AMBIT ENGINEERING, INC. CIVIL ENGINEERS AND LAND SURVEYORS

RE: Request for TAC Site Plan Approval at 41 Salem Street, Tax Map 144 / Lot 31

The project received a Technical Advisory Committee recommendation of approval at the April 13, 2020 Technical Advisory Committee Meeting subject to stipulations. The stipulations, as well as our responses to the stipulations, are listed below:

PROPOSED RESIDENTIAL DEVELOPMENT 41 SALEM STREET PORTSMOUTH, NEW HAMPSHIRE PERMIT PLANS

UTILITY PLAN **C3**

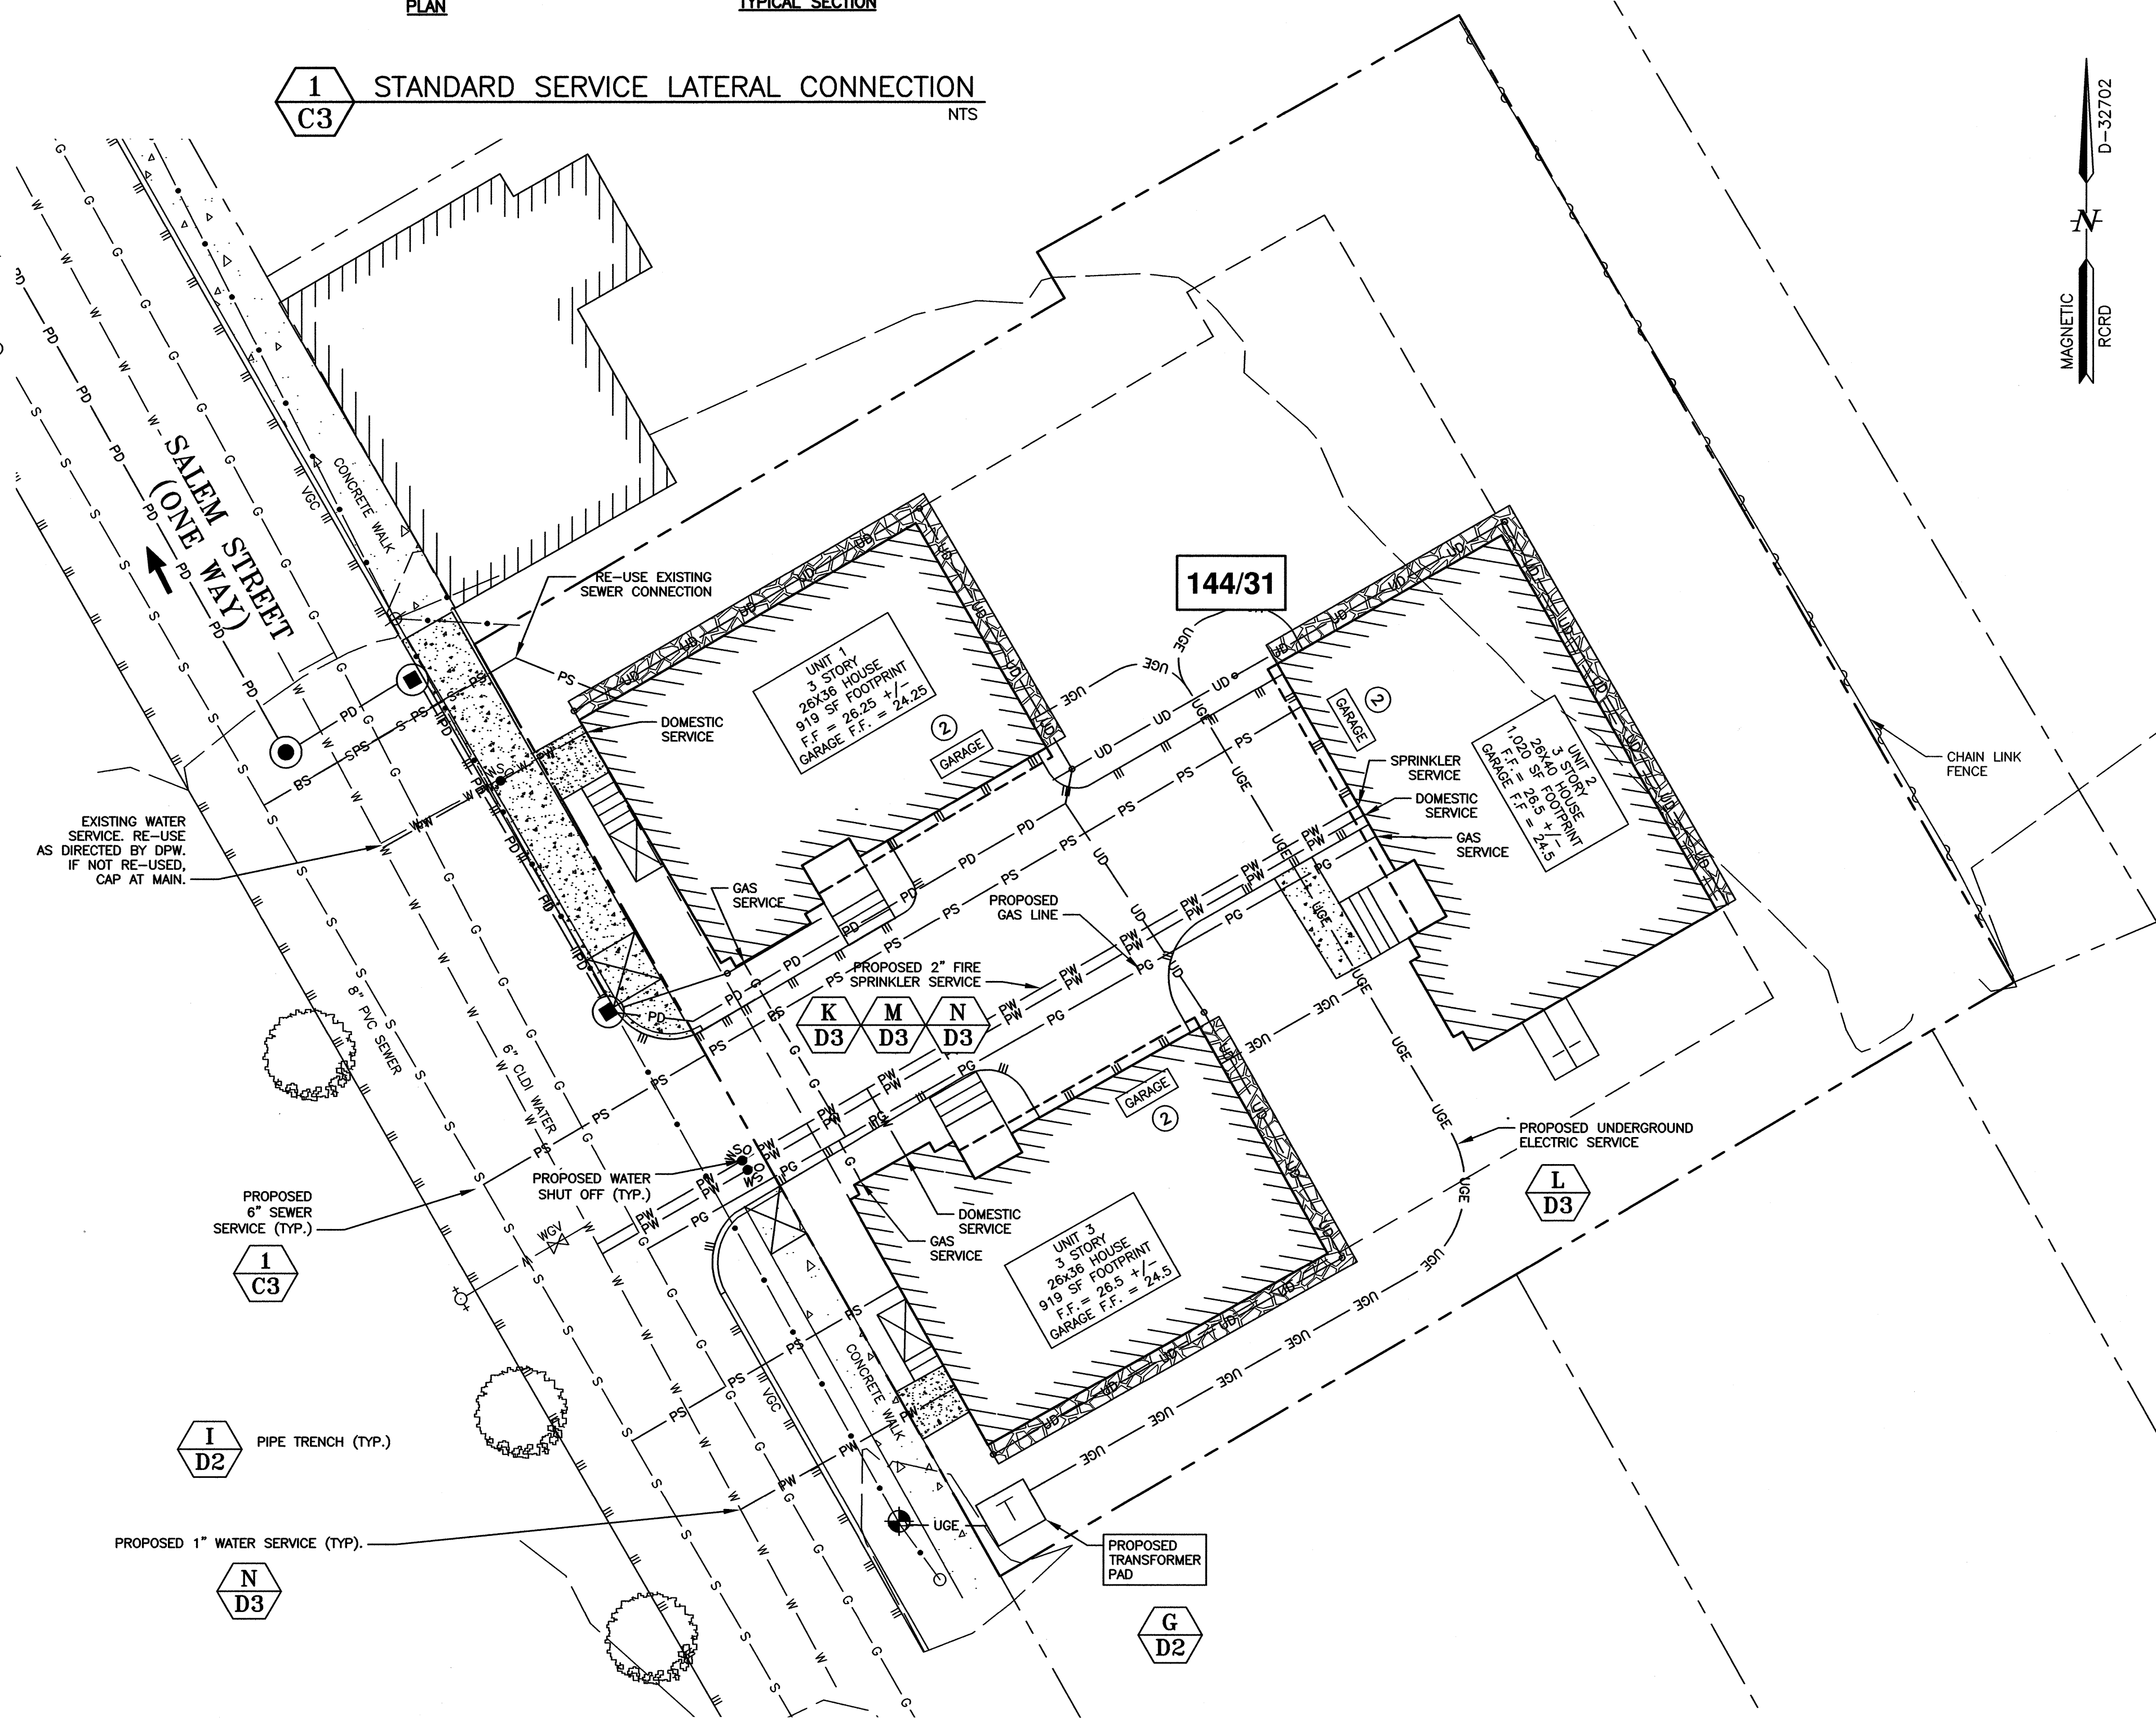
1. Plans shall be updated as follows:
 - a. Show existing sewer service on Existing Conditions plan and reuse as directed by DPW; **The sewer service is shown on Sheets C1 and C3.**

- b. Revise water service line sizes to be 1"; **This is shown on Sheet C3.**
 - c. Provide individual water and fire services for unit 2 ~~–4" main with services from the main as discussed at TAC~~; **This is shown on Sheet C3.**

- d. Provide water service for unit 3 as discussed at TAC; **This is shown on Sheet C3.**
 - e. Move proposed catch basin out of new driveway downhill so that it is in the curbed area, make 45 degree bend on underdrain to do this; **This is shown on Sheet C4.**

- h. Add required note for existing water service to be capped at the main; **This is shown on Sheet C3 (if not re-used).**
 - i. Add note to plans that any damage to existing sidewalks to be repaired to DPW satisfaction; **This is shown on Sheet C2 as Note 12.**

- n. Use Ergo XL hinged cover marked "Drain" for DMH(s); **This is shown on Sheet D2, Detail J.**
 - o. Provide sewer service details showing 6" PVC services with wyes cut into main and patched back in with pvc repair couplings (no rubber 'Fernco' couplings allowed); **This is shown on Sheet C3, Detail 1.**

PLANTING KEY AND SCHEDULE

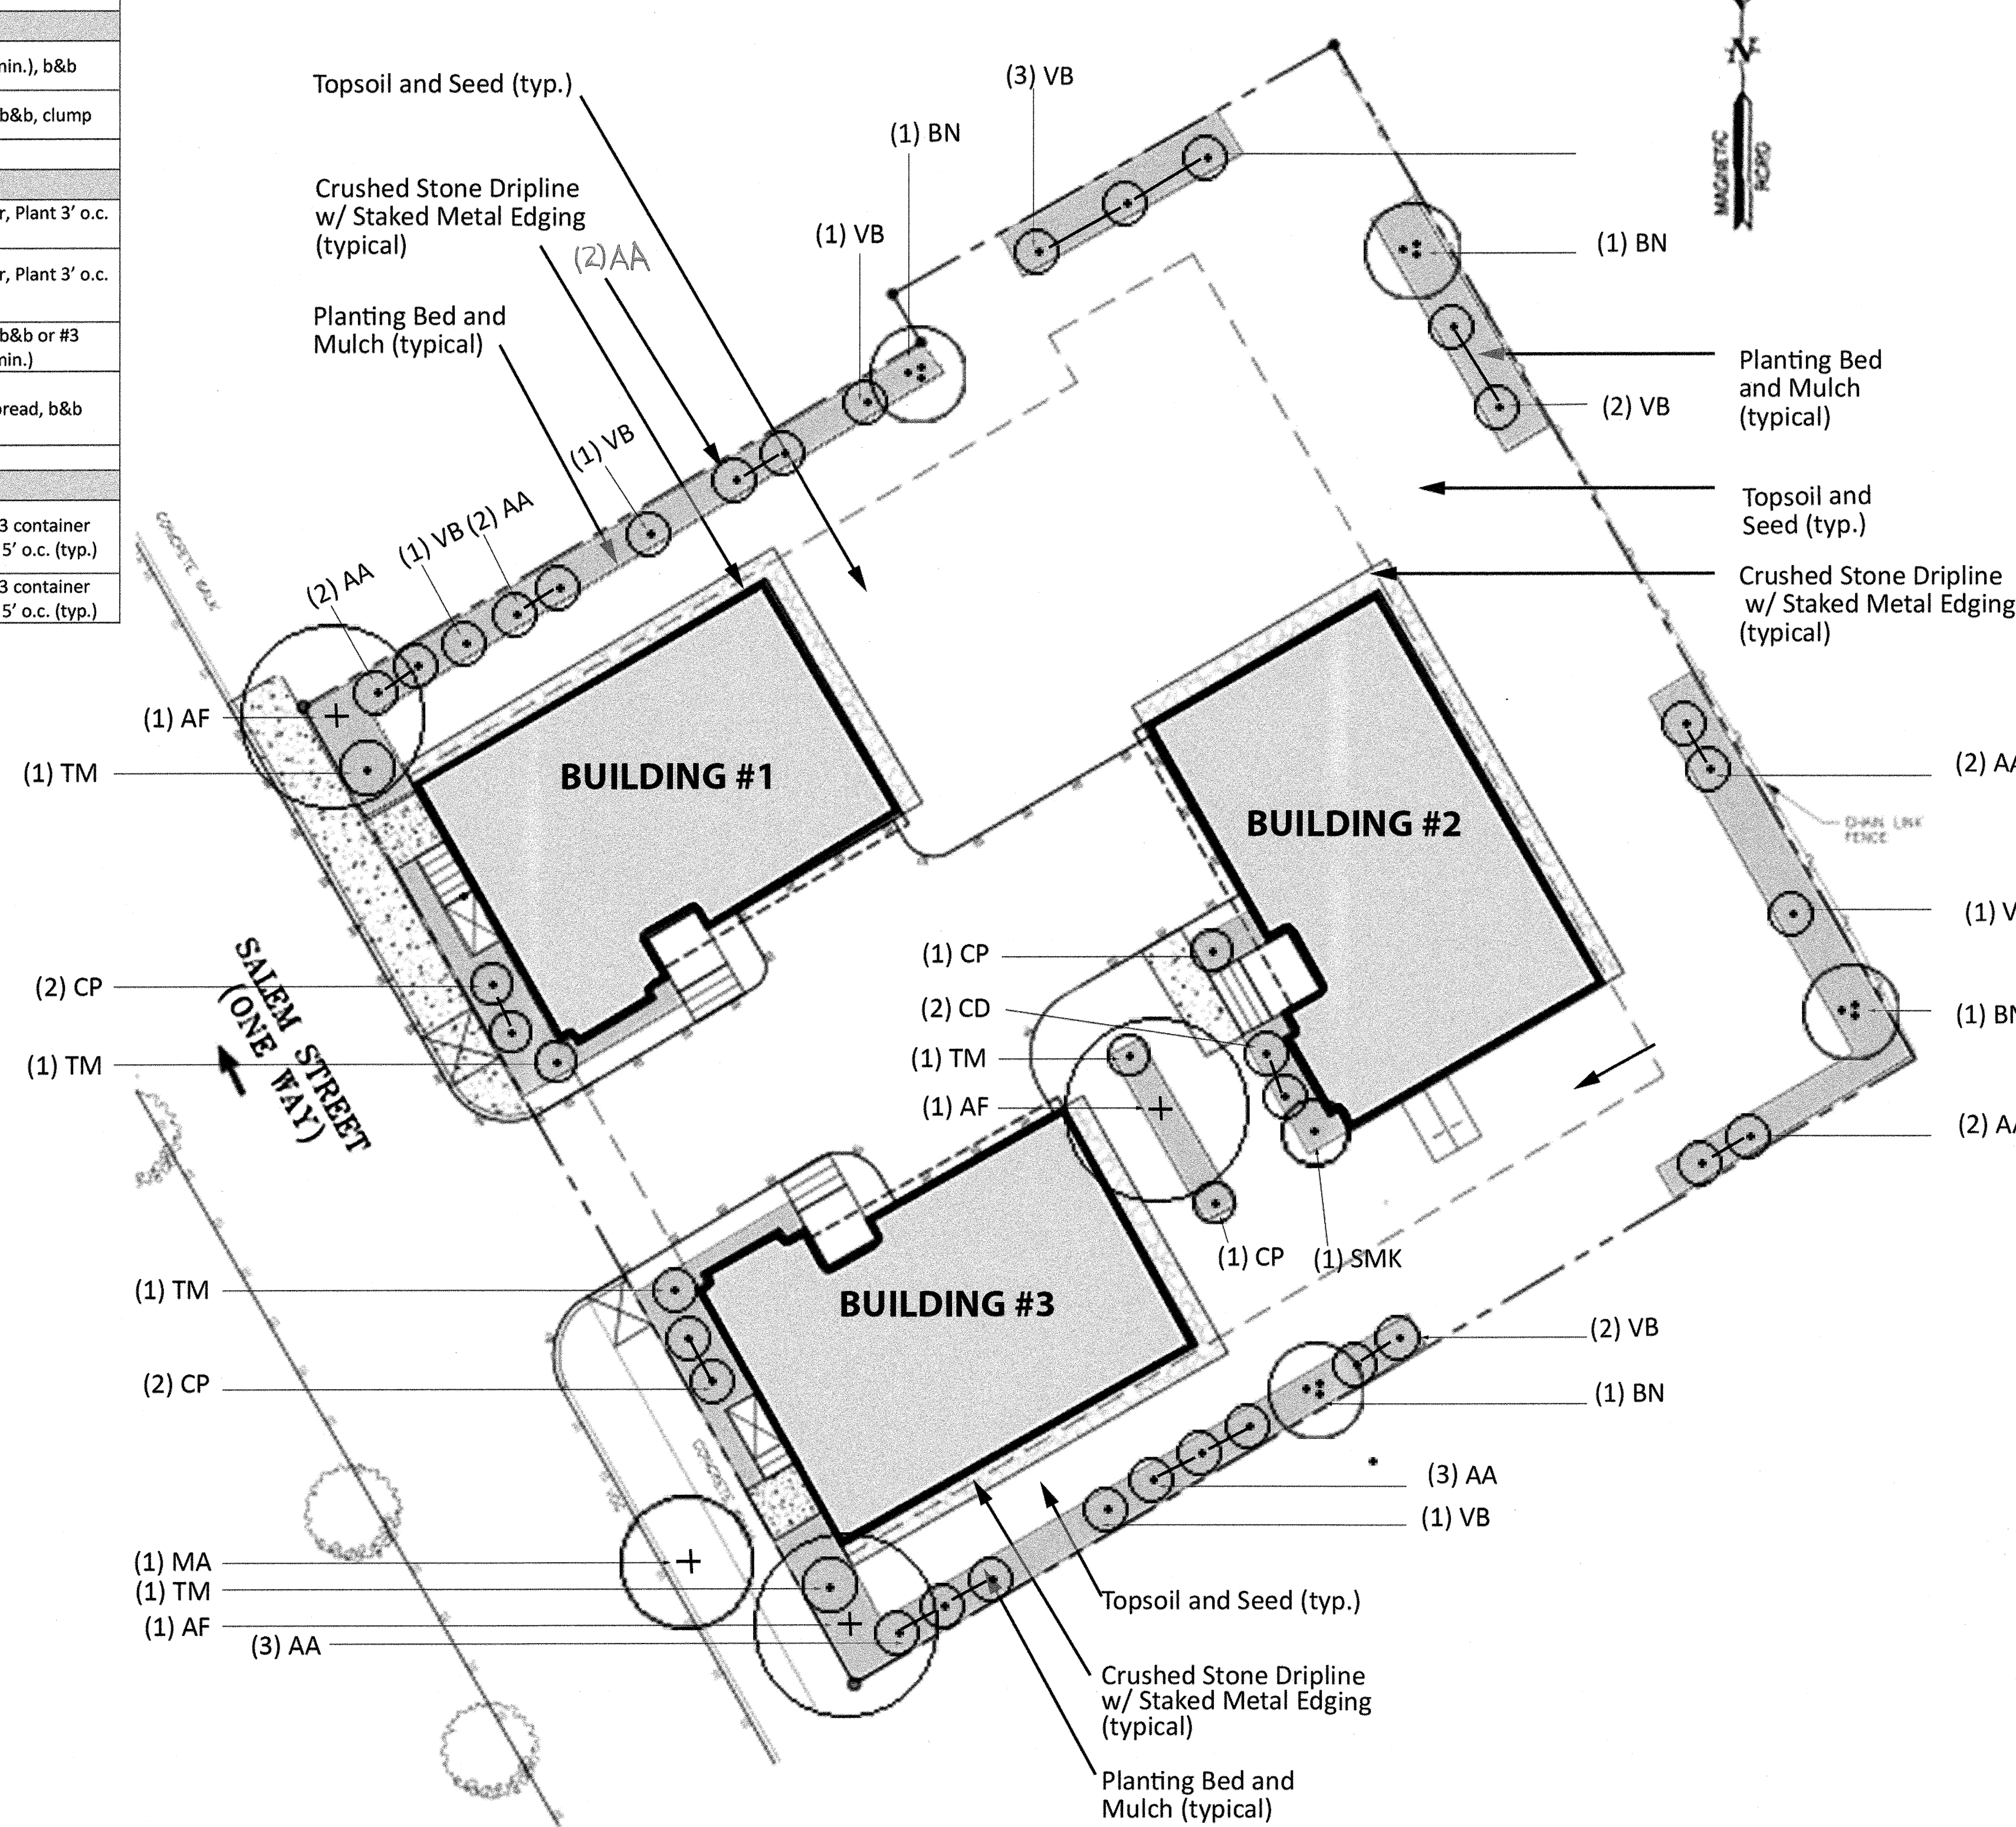
2. Landscape Plan to be updated as described to TAC to make sure any plantings at corner of driveway are less than 3.5 feet tall so that they do not block sight lines of drivers exiting onto Salem Street. **The three plantings potentially in conflict are as follows:**
 - a. **SDW – Lilac: The Landscape Architect has recommended that we substitute a TM (Taxus x media Tautonii) for the Lilac. This plant is a**

- b. **CP – Sweet Fern: this will not grow to that height.**
 - c. **MA – Amur Meechia: this species was picked by the Trees and Greenery Committee. At planting the specific specimen can be chosen to be more upright with a higher branching structure. Lower limbs will need to be pruned for the sidewalk, which is along the sight line. All changes are shown on Sheet C5.**
3. Landscape Plan to be updated to match site plan for building footprint and style. **This is shown on Sheet C5.**
 4. Proposed building designs to be reviewed with Planning Department for further guidance on architectural design and abutter concerns regarding building height. **Guidance was received in an email from Planning Staff dated April 27. Plans revised to try to address the suggestions.**

evergreen, b) low growing/spreading, c) well suited to this location, and d) already included in the project's plant list.
